**Pacific Gas and  
Electric Company®**

PG&E Letter DCL-14-076

Diablo Canyon Units 1 and 2

Pacific Gas and Electric Company's Third Six-Month Status Report in Response to  
March 12, 2012, Commission Order Modifying Licenses with Regard to  
Requirements for Mitigation Strategies for Beyond-Design-Basis External Events  
(Order Number EA-12-049)

Figure 6A  
All Strategies – Primary  
Unit 1 and 2  
Elevation 115'

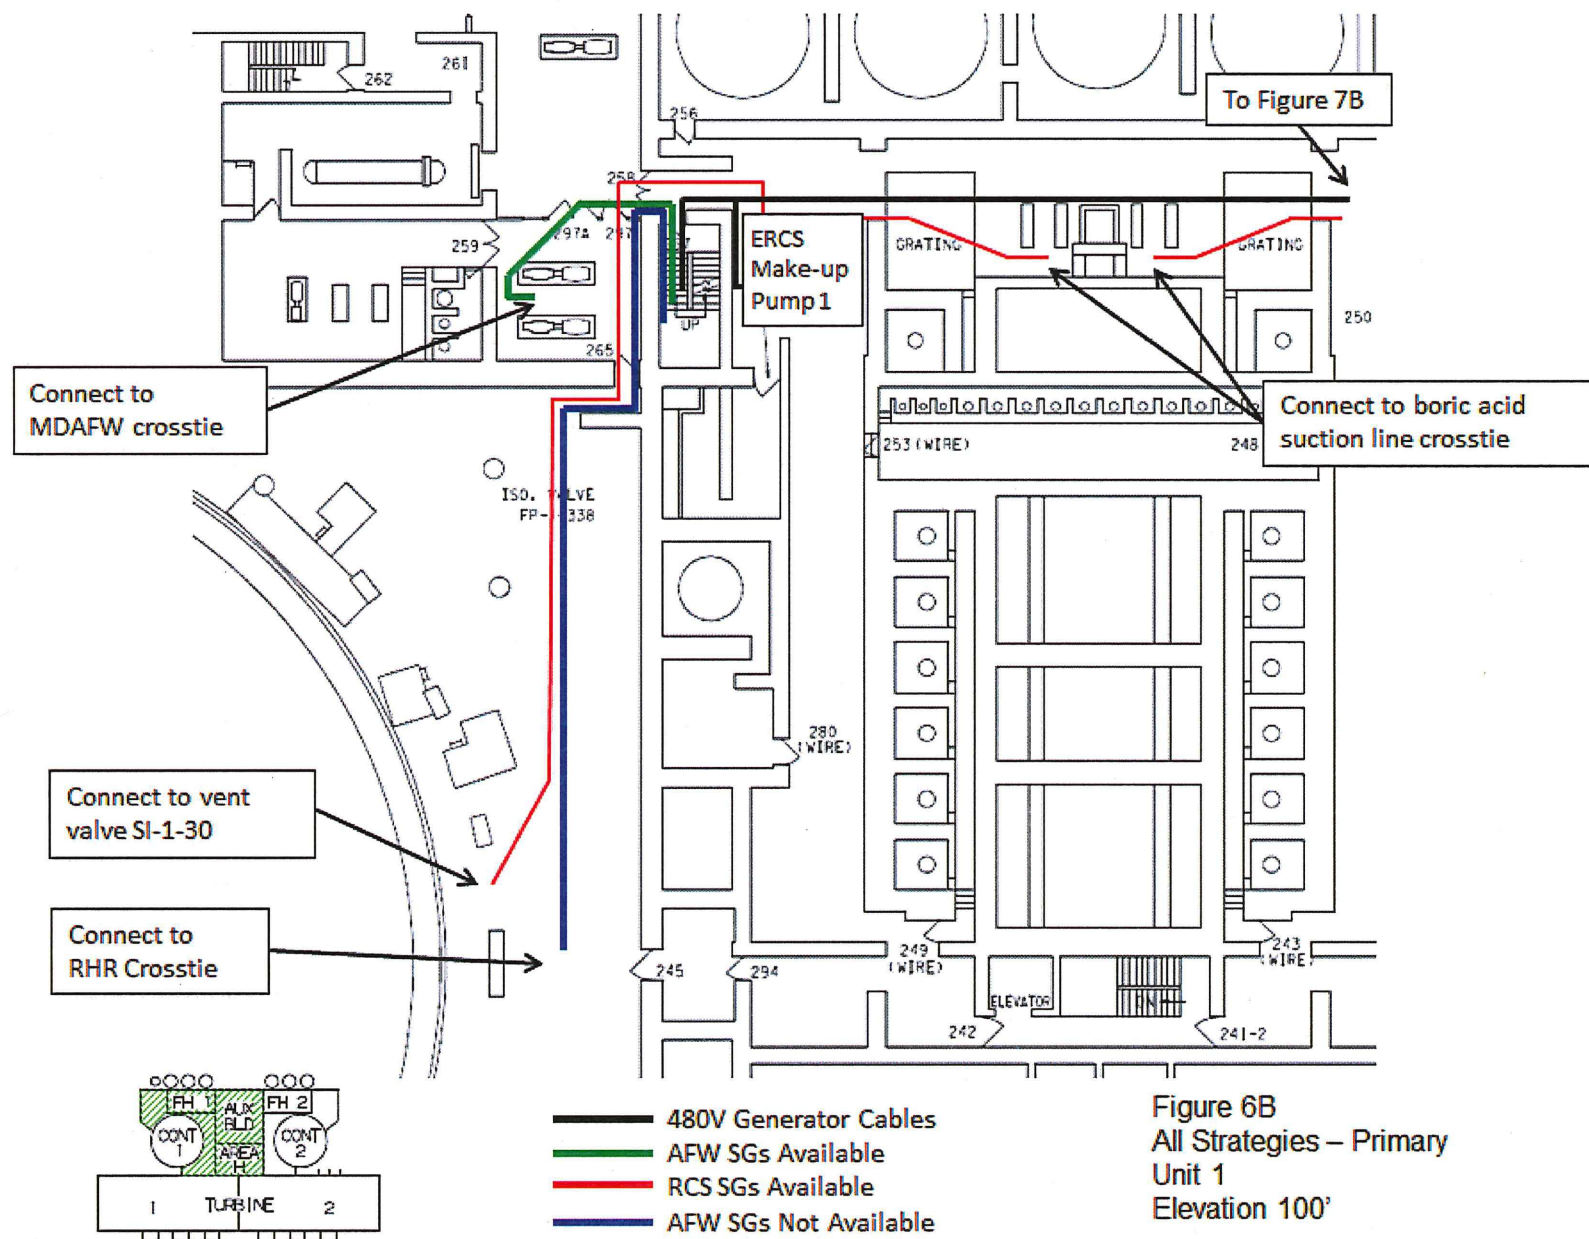
(1) Figure 6A Revisions:

- (a) Removed the ESFP pump from the SFP hose line.
- (b) Clarified the legend to state “SFP Flexible Hose.”
- (c) Modified route for the SFP flexible hose to be routed up the stairs to the SFP.
- (d) Clarified the title for the 480-V generator powering the ERCS make-up pumps.
- (e) Removed the staging location for the ERCS make-up pumps from the 115-foot elevation (now on the 100-foot elevation).
- (f) Modified route for 480-V generator cables to be routed down the stairwell for the ERCS make-up pumps.
- (g) Updated the legend to include route for 480-V generator cables for powering the ERCS make-up pumps.
- (h) Updated the legend to remove reference to “RCS SGs Available.”
- (i) Clarified “To Unit 2” to “To Figure 7A.”

Figure 6B  
All Strategies – Primary  
Unit 1  
Elevation 100'

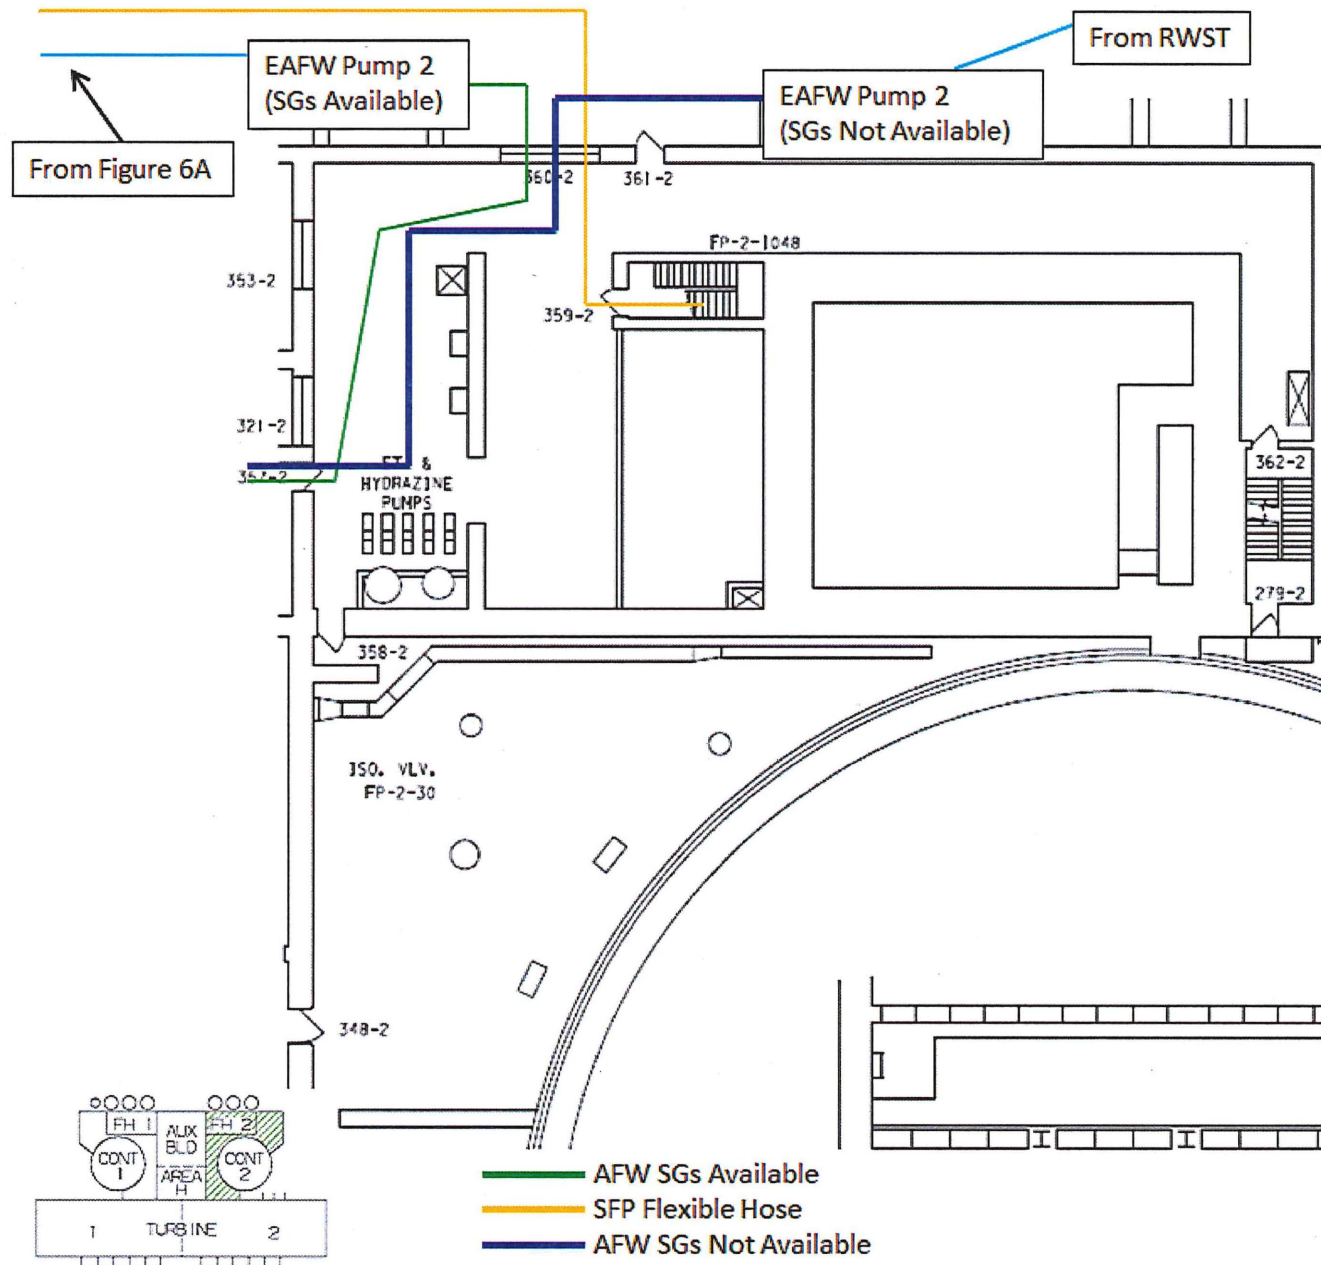
(2) Figure 6B Revisions:

- (a) Added staging location for the Unit 1 ERCS make-up pump.
- (b) Added route for 480-V generator cables to the ERCS make-up pumps.
- (c) Updated the legend to include route for 480-V generator cables for powering the ERCS make-up pumps.

Figure 7A  
All Strategies – Primary  
Unit 2  
Elevation 115'

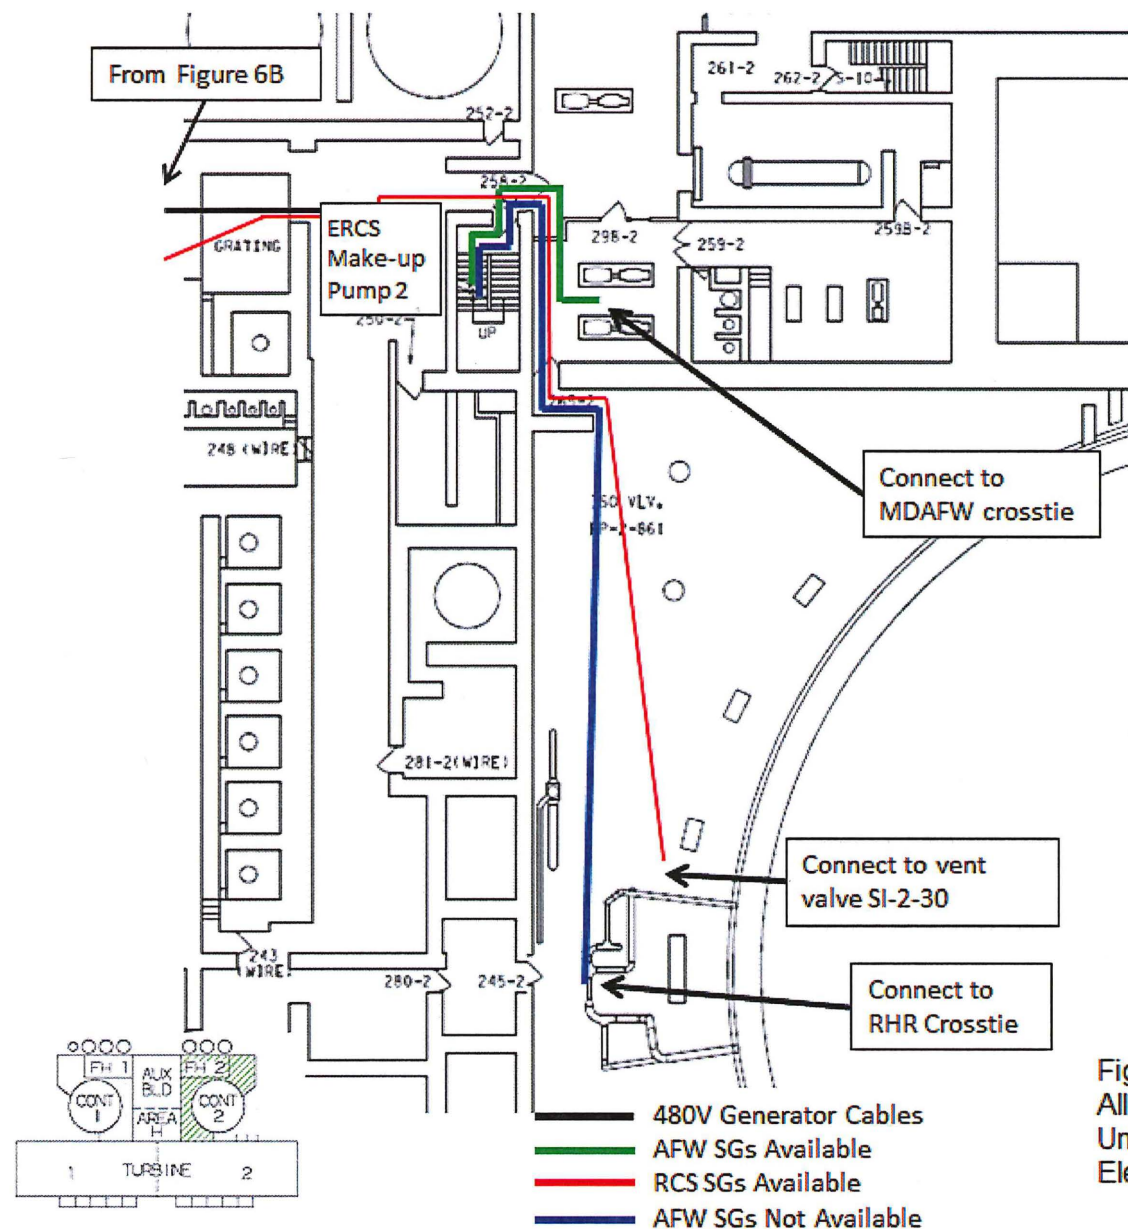
- (e) Added note "To Figure 7B" for lines that connect to the Unit 2 ERCS make-up pump.
- (3) Figure 7A Revisions:
- (a) Removed the ESFP pump from the SFP hose line.

- (b) Clarified the legend to state "SFP Flexible Hose."
  - (c) Modified route for the SFP flexible hose to be routed up the stairs to the SFP.
  - (d) Updated the legend to remove reference to "RCS SGs Available."

- (e) Clarified "From Unit 1" to "From Figure 6A."
- (4) Figure 7B Revisions:
- (a) Added staging location for the Unit 2 ERCS make-up pump.
  - (b) Added route for 480-V generator cable to the ERCS make-up pump.

Figure 7B  
All Strategies – Primary  
Unit 2  
Elevation 100'

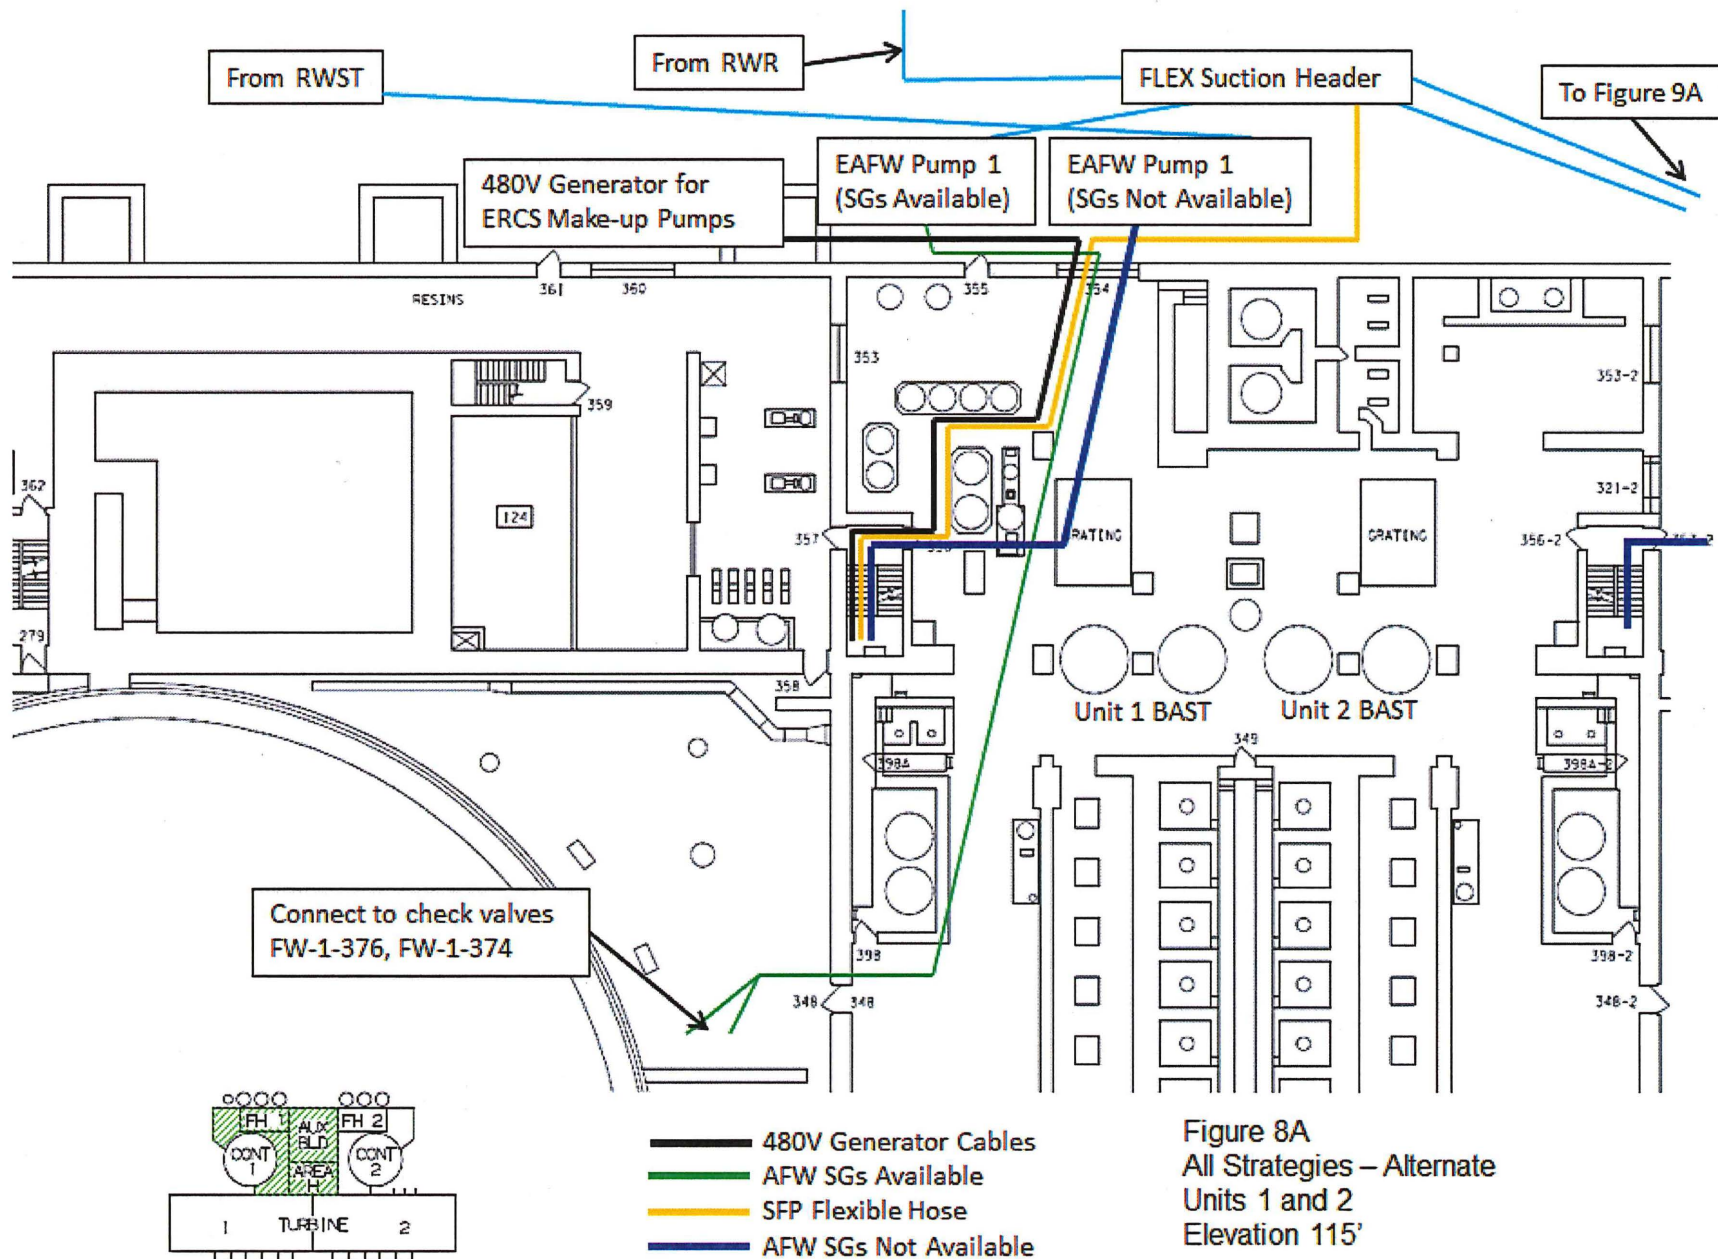
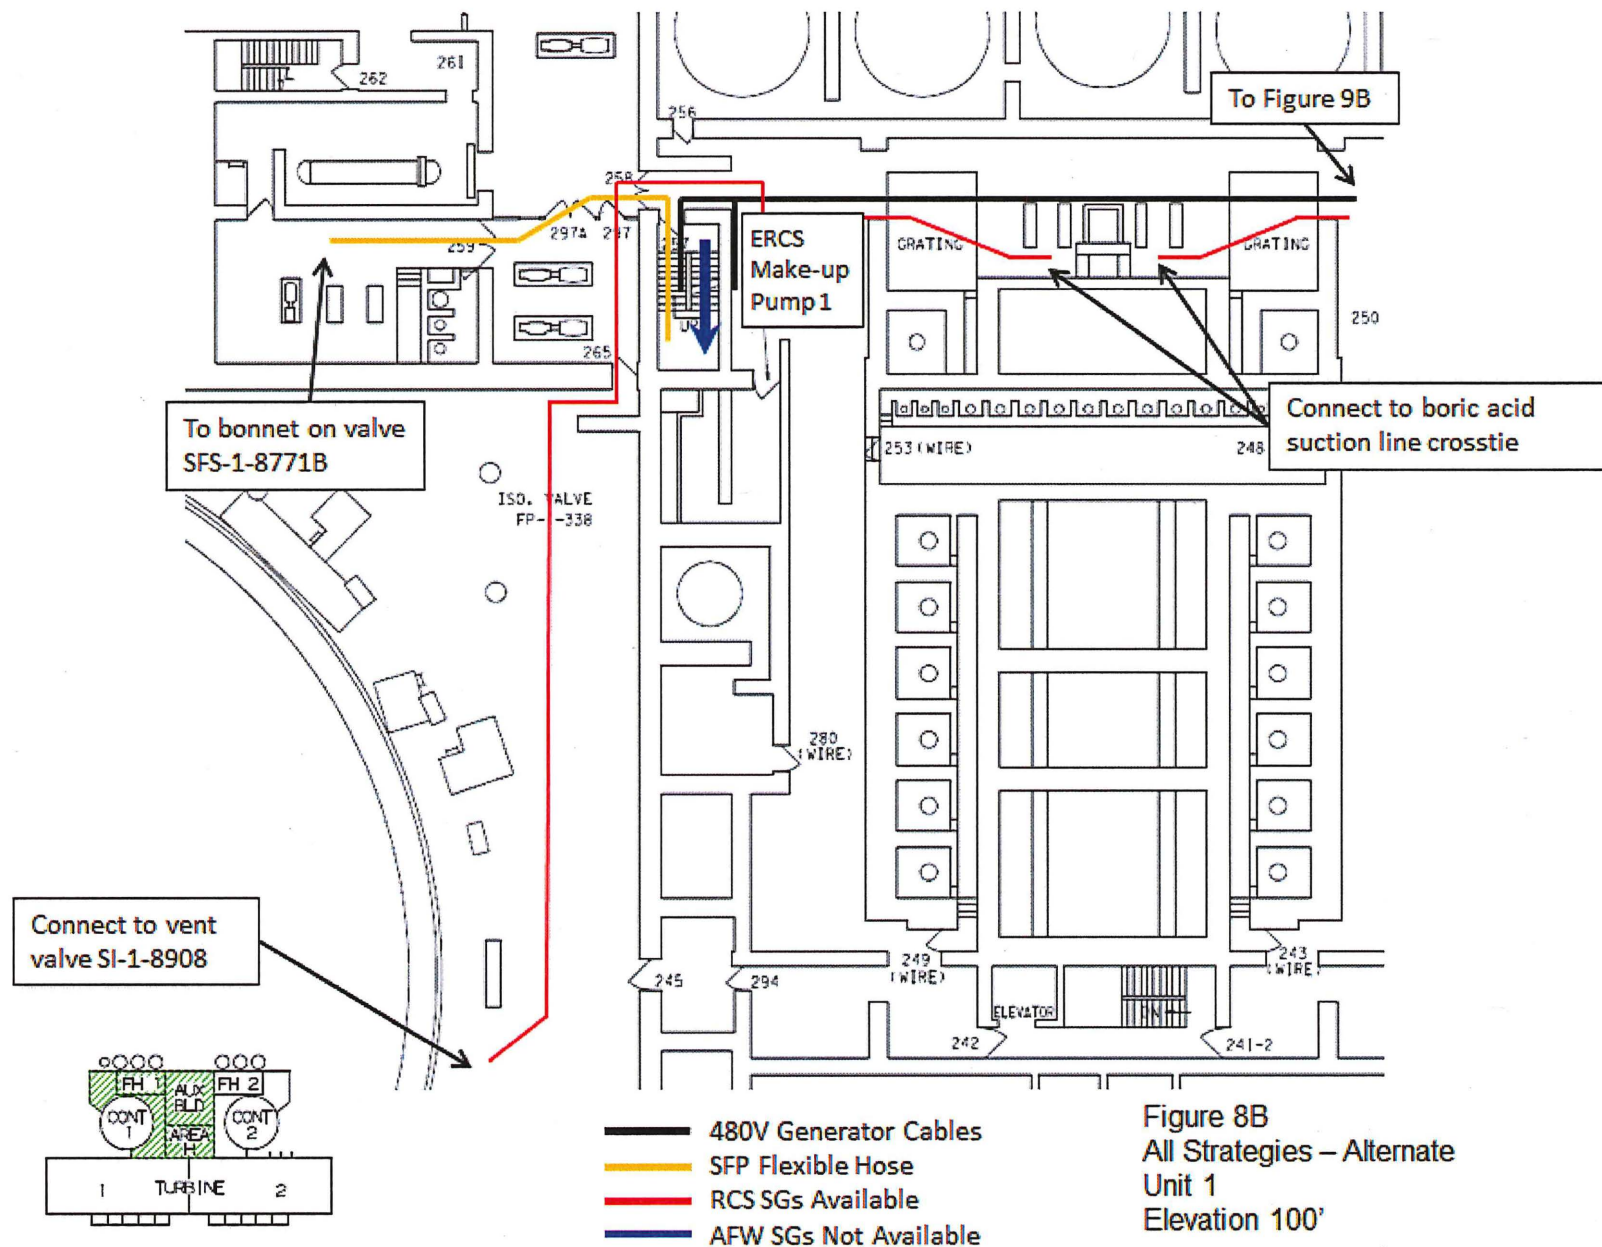
- (e) Added note "To Figure 6B" for lines that connect from the Unit 2 ERCS make-up pump.
- (5) Figure 8A Revisions:
- (a) Removed the ESFP pump from the SFP hose line.
